Steepbank Mine Project

Supplemental Information Response

**SUPPLEMENTAL INFORMATION RESPONSE
STEEPBANK MINE PROJECT
EUB APPLICATION NO. 960439
AEP APPLICATION NO. 020-95, AND FILE NO. 27551**

The following information is provided in response to the Energy and Utilities Board and Alberta Environmental Protection supplemental information request dated July 12, 1996. The following response follows the outline of your supplemental request letter.

Figure 5.6-1

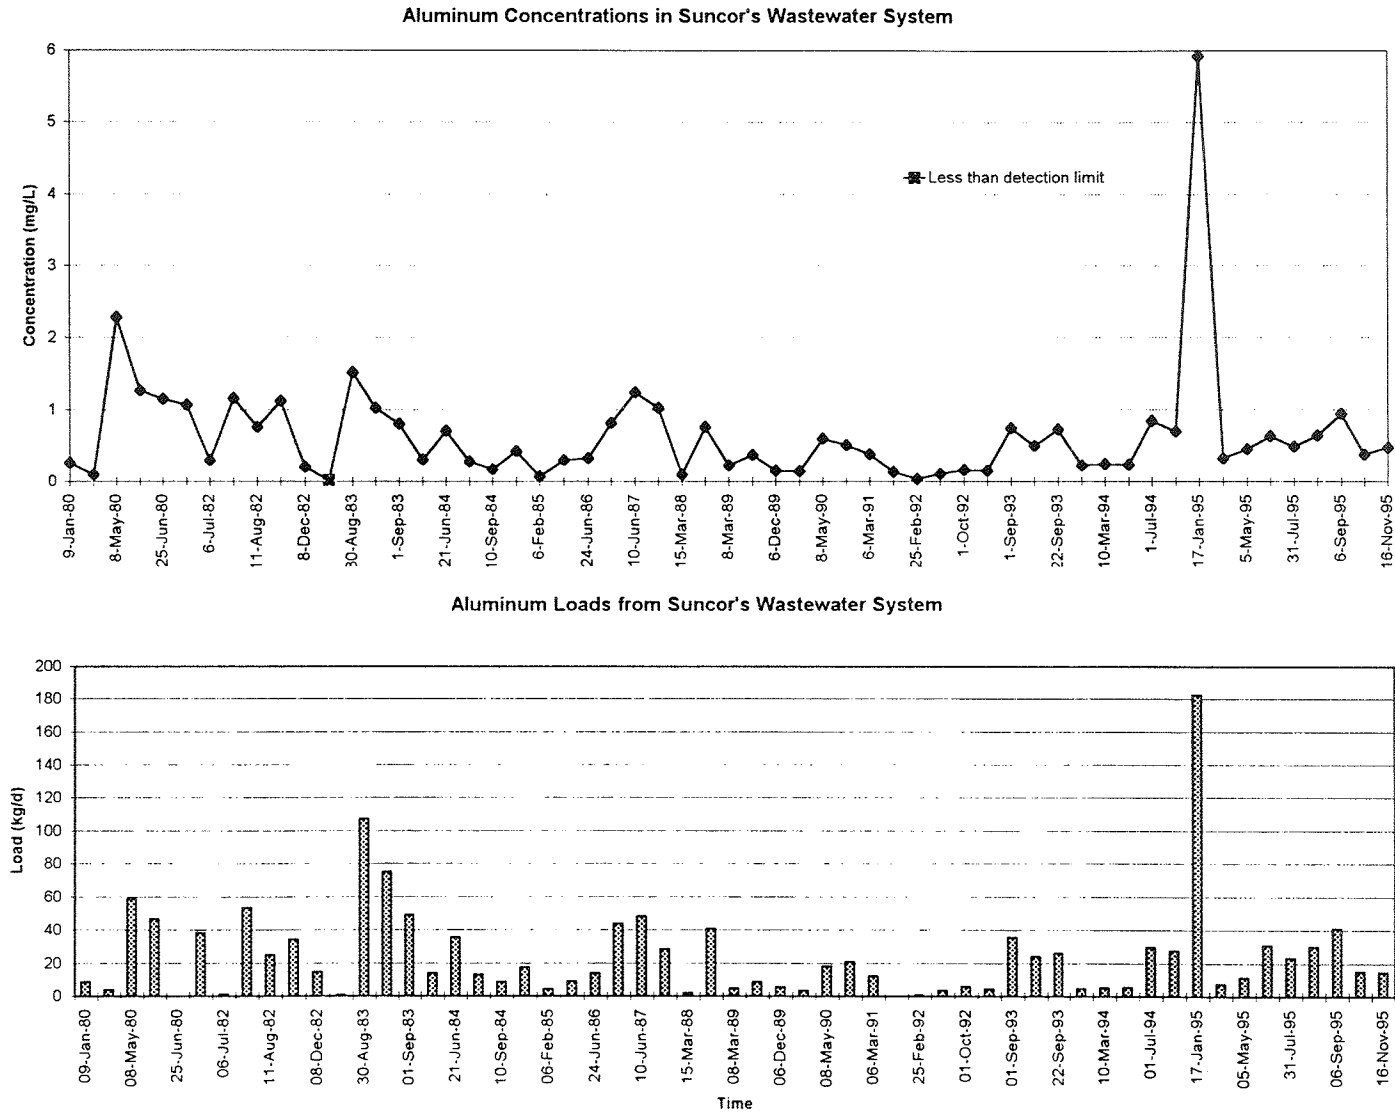
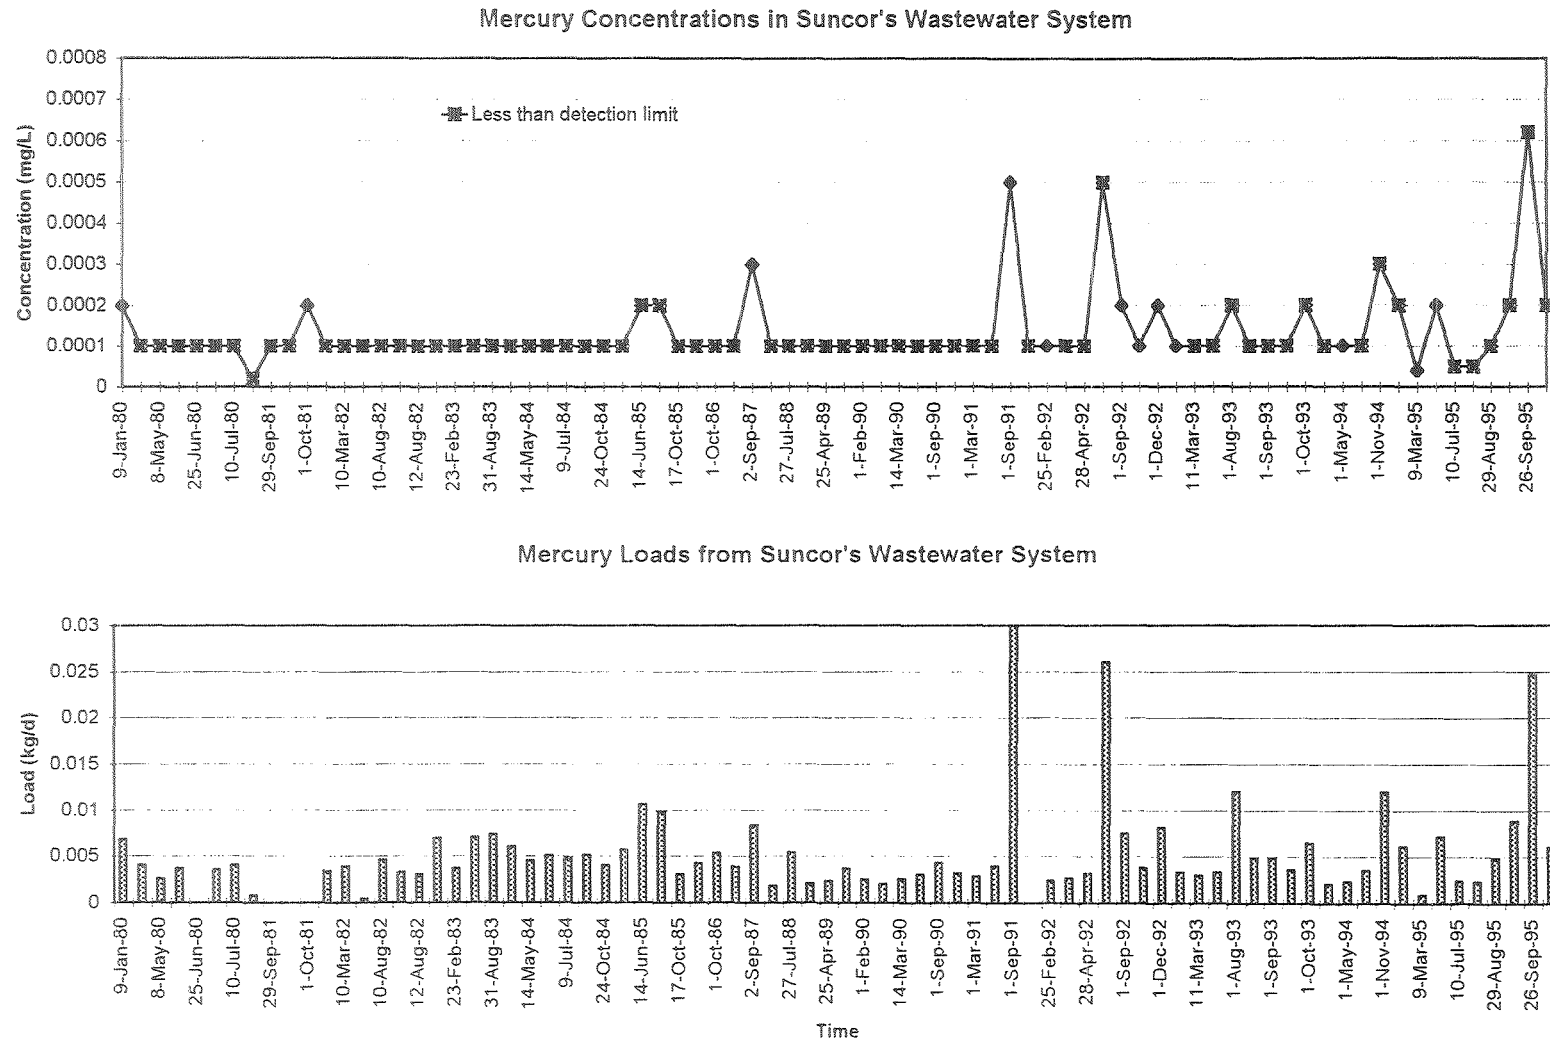
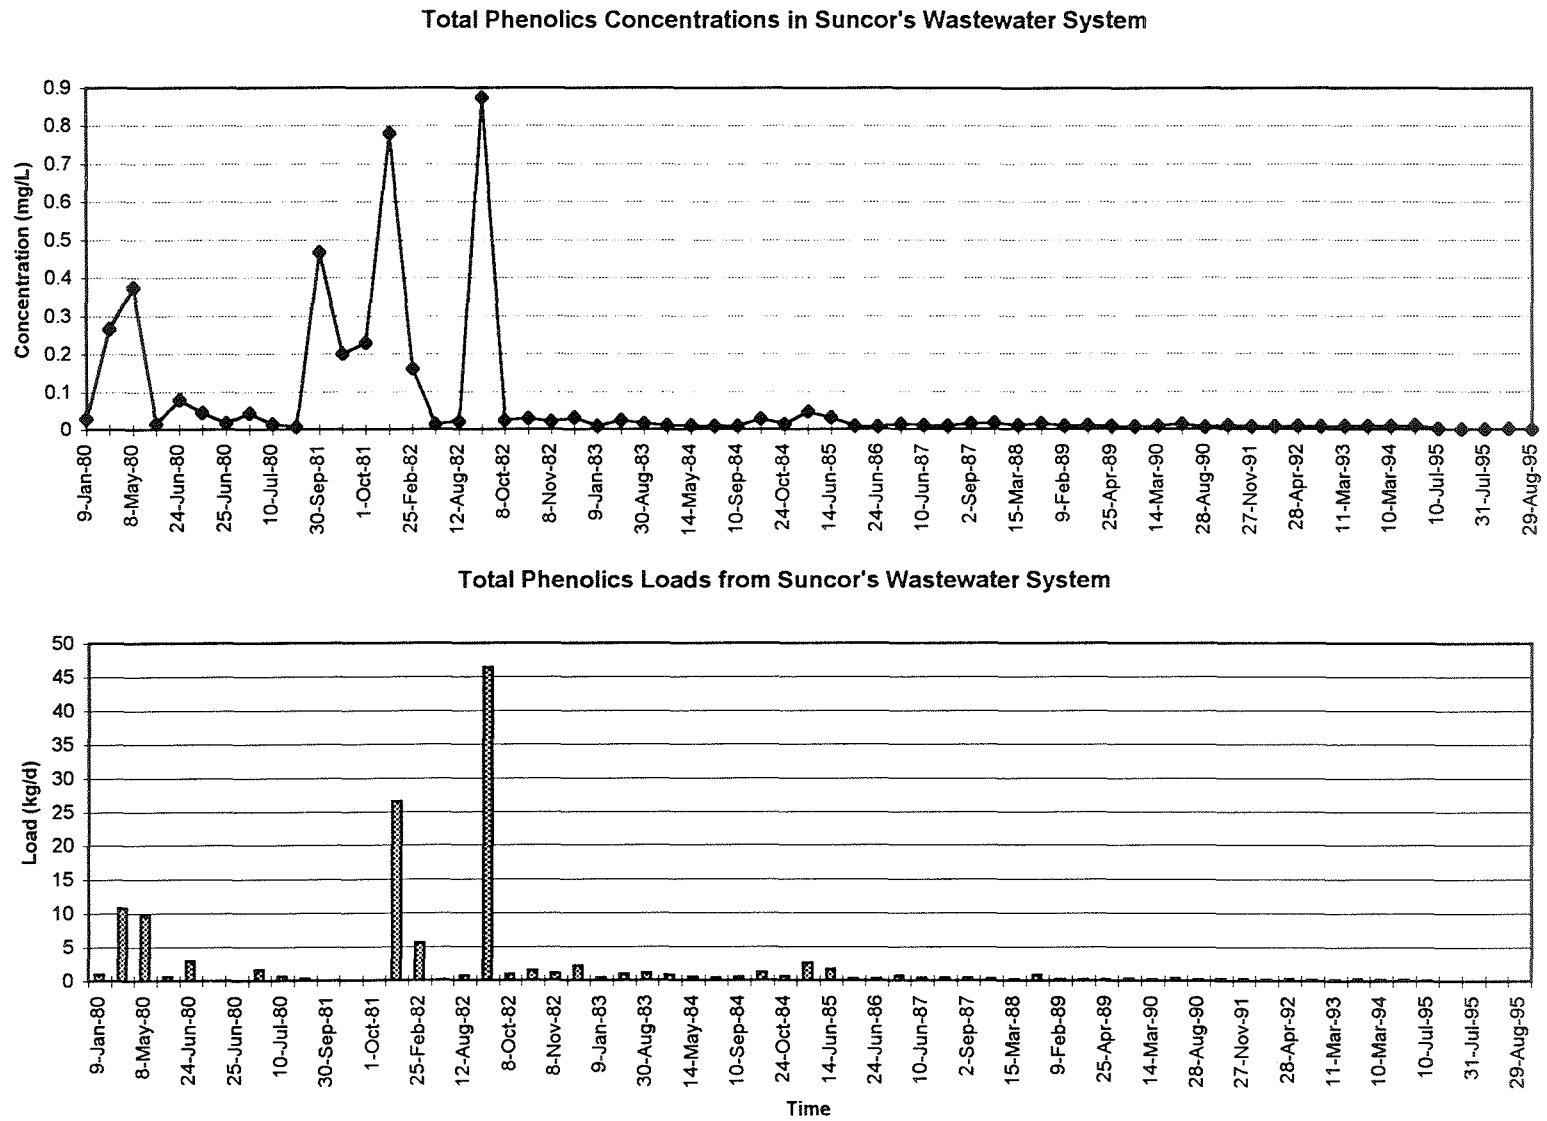
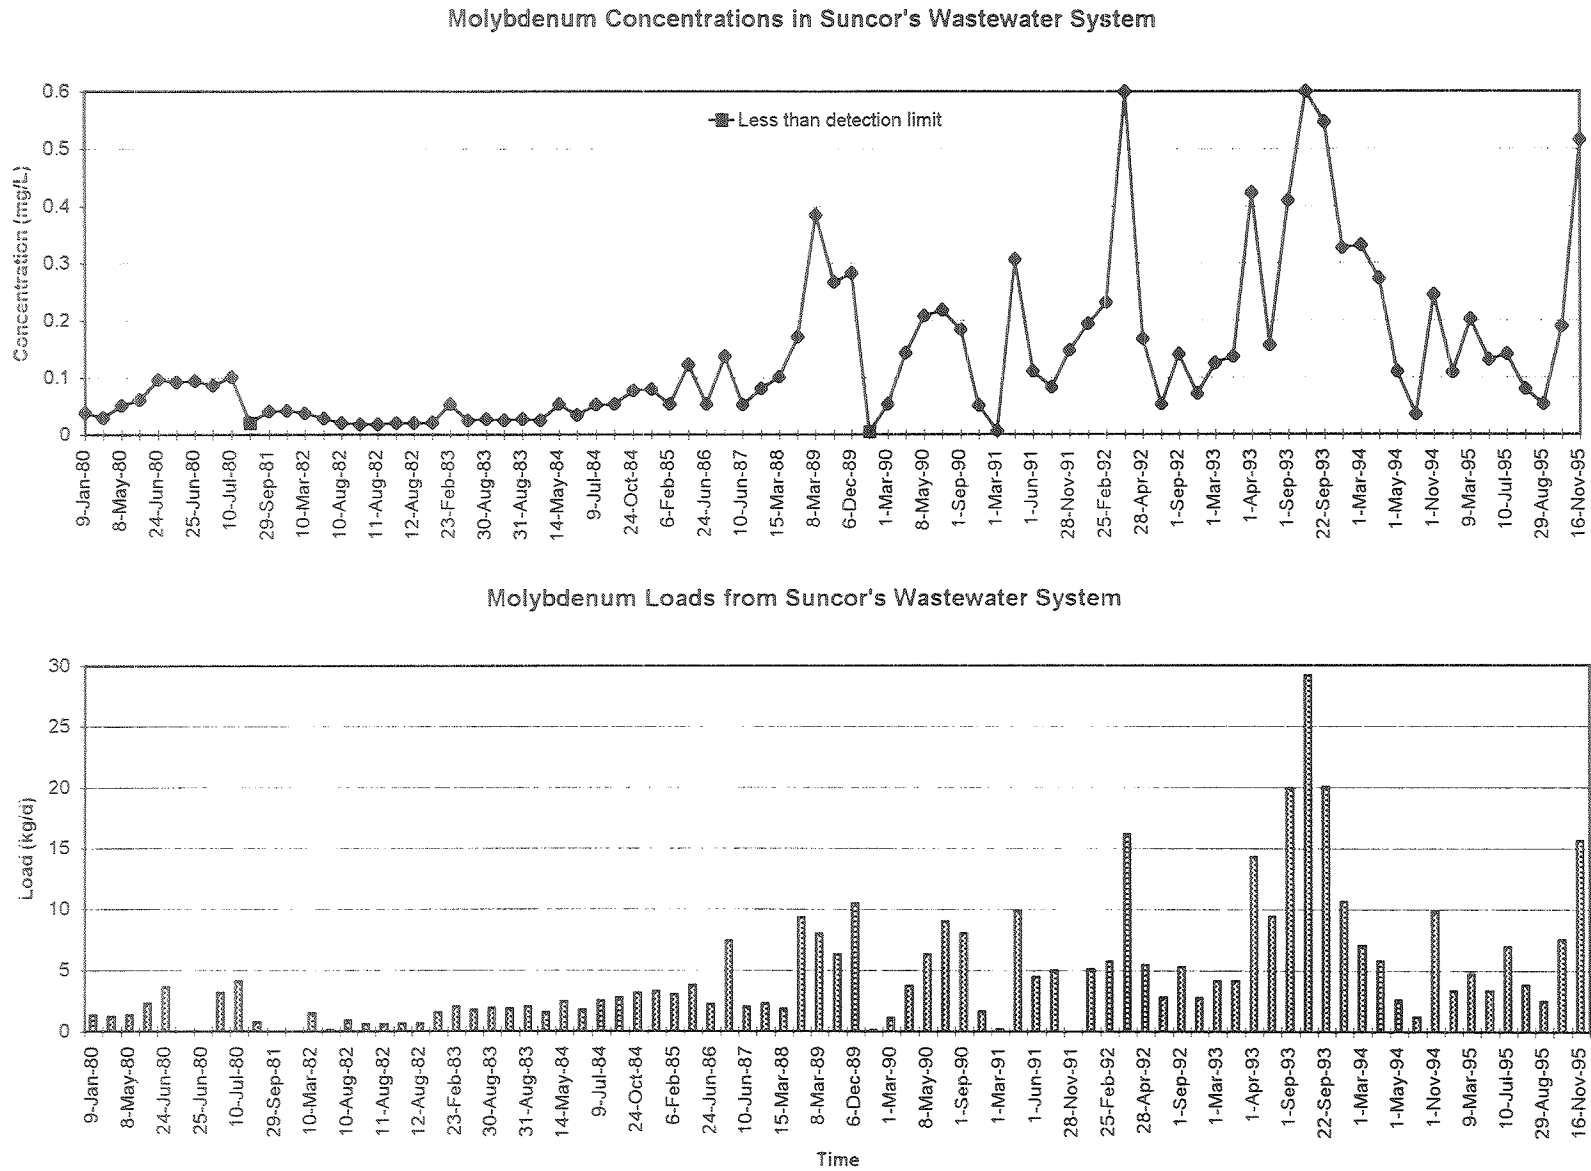
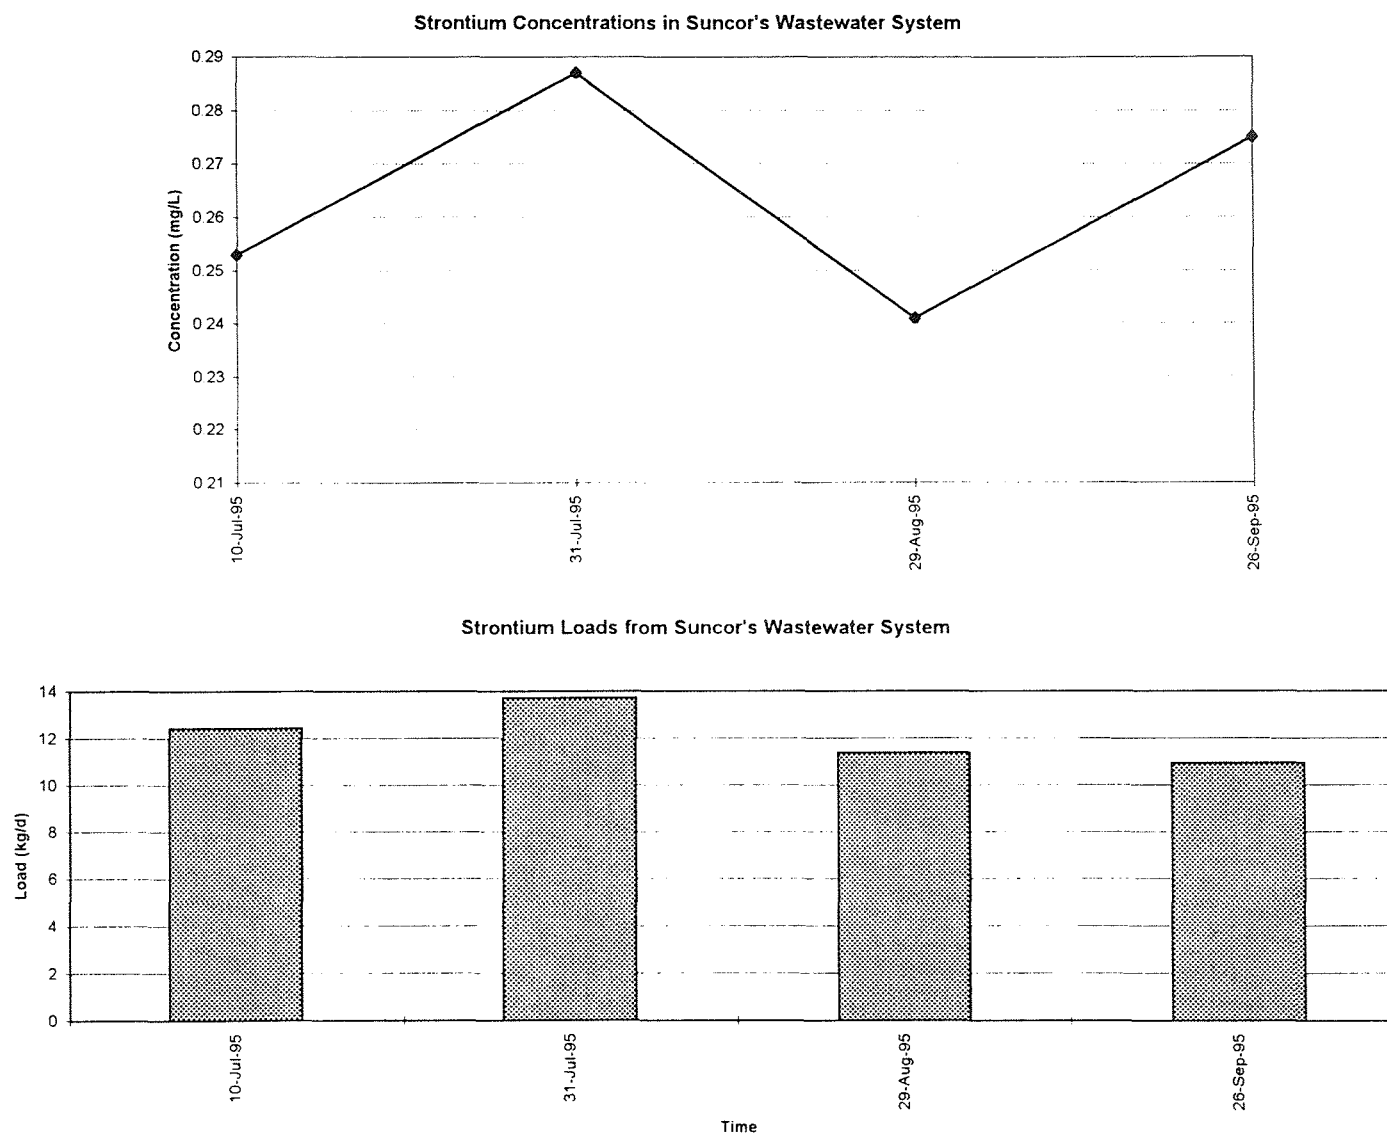
Q5.6 Provide time series graphs of wastewater concentrations/loadings for aluminum, mercury, phenols, molybdenum, and strontium (*Athabasca River Water Releases Impact Assessment, May 1996, p.23*). What plans does Suncor have to monitor these substances in the future?
